## CHD/713/5 & CHD/713/6-CA – Mr G Chambers

Extension and alterations to existing house, demolition of barn and erection of annex.

Land at Penn House, High Street, Childrey, Wantage, Oxon.

**CHD/713/5 & CHD/713/6 - CA – Mr. G Chambers**  
**Extension and Alterations to Existing House, Demolition of Barn and Erection of Annex.**  
**Rebuild South and east External Walls of House.**  
**Land at Penn House, High Street, Childrey, Wantage, Oxon. OX12 9UW.**

CLIENT  
 Mr Gareth Chalmers  
 17535-SG  
 PROPOSED RE-DEVELOPMENT AT  
 PENN HOUSE, HIGH ST  
 CHILDREY OX12 9JA  
**FIRST FLOOR PLAN &  
 ELEVATIONS - AS PROPOSED**

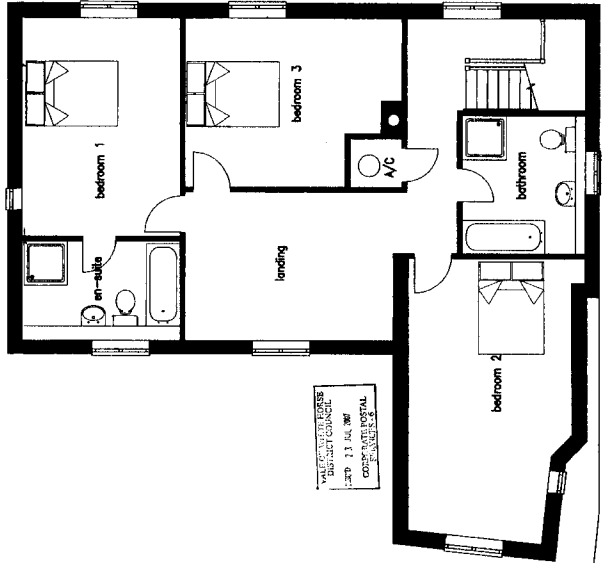
1. All the glazing and the "Juliet" window on the first floor of the extension facing north have been removed. The proposed bedroom will be served by a centralized window on the west facing gable.
2. The dormer window on the west elevation closest to the neighbouring boundary, which serves the en-suite bathroom, is shown with obscured glazing. A further change to this elevation involves the continuation of the roof as an overhang, which serves to give it more of a cat-slide appearance.
3. The height of the annex has been reduced by 0.5 metre, and the entrance porch detail has been made less elaborate.
4. One of the French windows on the east (front) elevation has been replaced by a conventional window.

"The Council broadly agrees that the proposed plans for the main house are much improved, however Councillors would like to see timber cottage style windows in the east elevation. Secondly, there is still much concern over the use of two access points onto Dog Lane, which has been the subject of previous correspondence. Finally, the Council requests that the rebuilt walls use the correct materials for the age of the property."

The point about the windows was in our letter of the 11<sup>th</sup> April 2007, had been specified in the conditions of the current consented scheme but is not shown on the plans with this application. The Parish Council would very much like to see timber cottage style windows, particularly in the east elevation, and modelled on other buildings of the same period in the area. They should be painted wooded casements with two or three lights in each window opening with each light sub-divided into two or three panes, with thin glazing bars in the correct period style. In a Conservation Area they would improve and enhance the building in line with policies HE1 and DC1 of the Local Plan.

**GROUND FLOOR PLAN  
 AS PROPOSED**

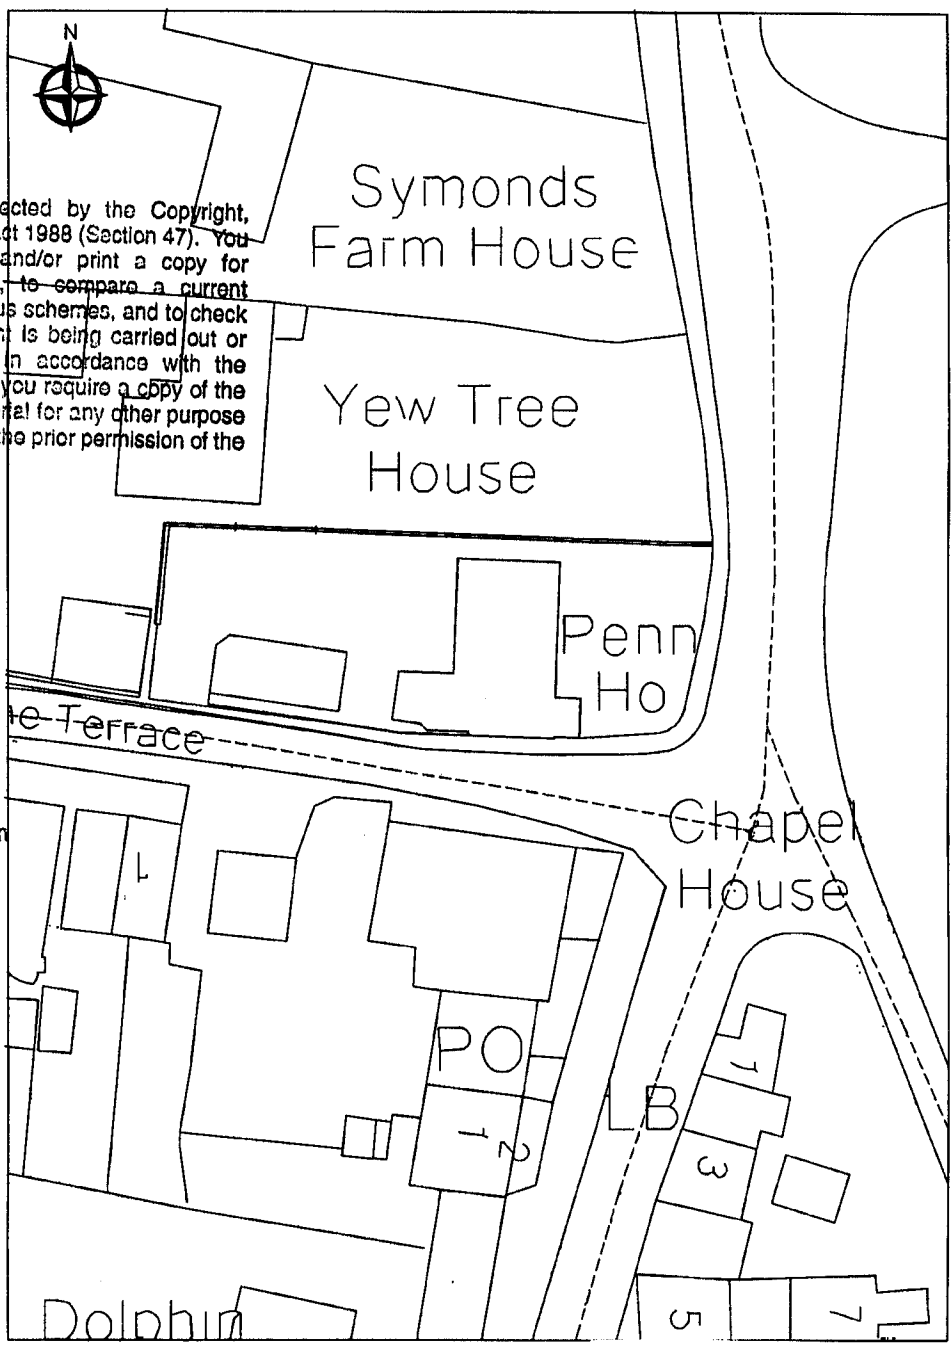
- The walls are rebuilt with the correct materials for the age of the property and, bearing in mind the appearance of the original building, reclaimed handmade bricks should be used and include the reinstatement of the polychrome features using the blue glazed headers on the front (East end) elevation.

**Drawing Title**  
 SITE LAYOUT

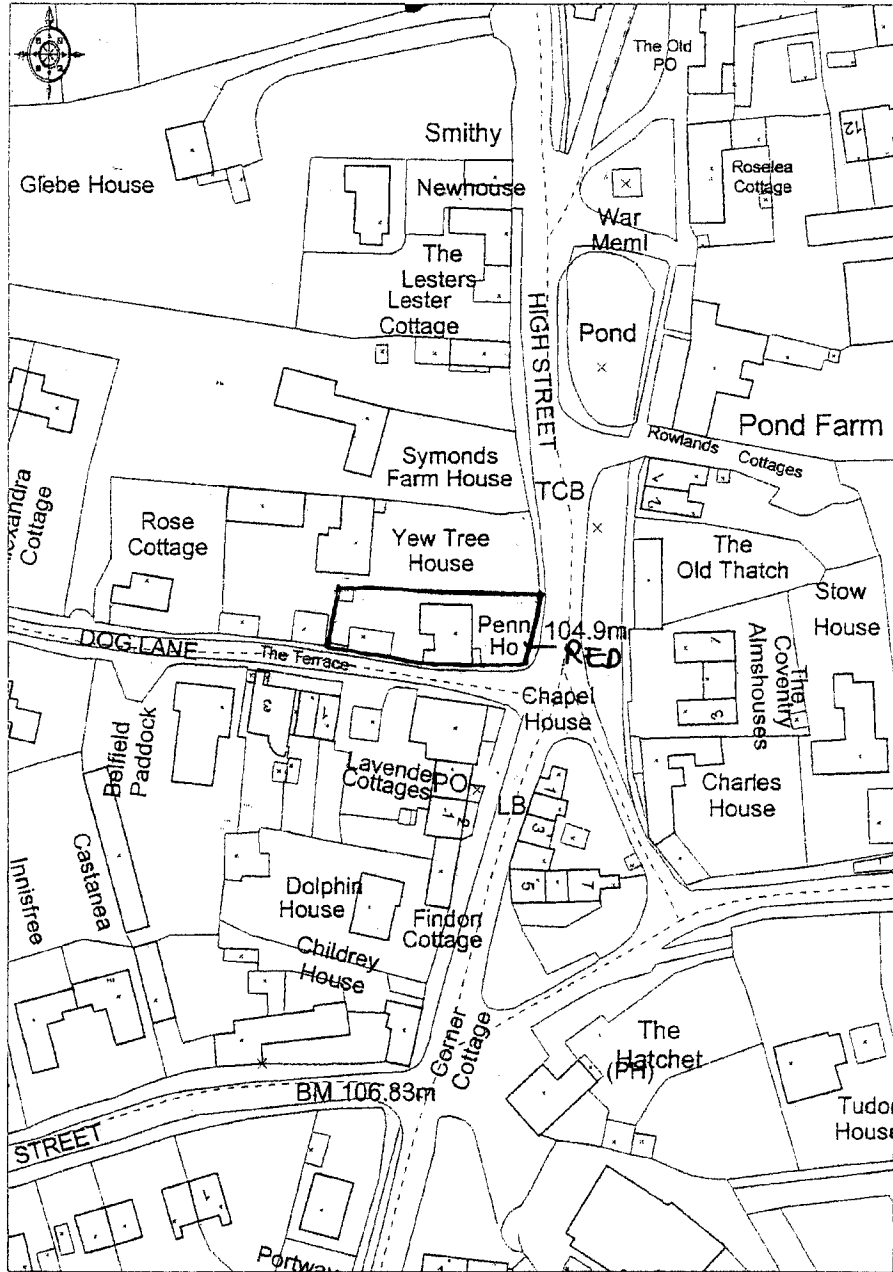
about the scale and appearance of the development have been addressed and the proposal is considered to meet the tests of acceptability within the terms of the above mentioned policies. Confirmation has been received that the applicant is willing to delete the garage proposal from the application. The removal of the garage from the scheme overcomes the remaining objections to the development. When interested parties heard of this change they pointed out that the removal of the garage would result in the loss of its screening effect allowing for a greater degree of overlooking. The following paragraphs address the points made by the objectors.
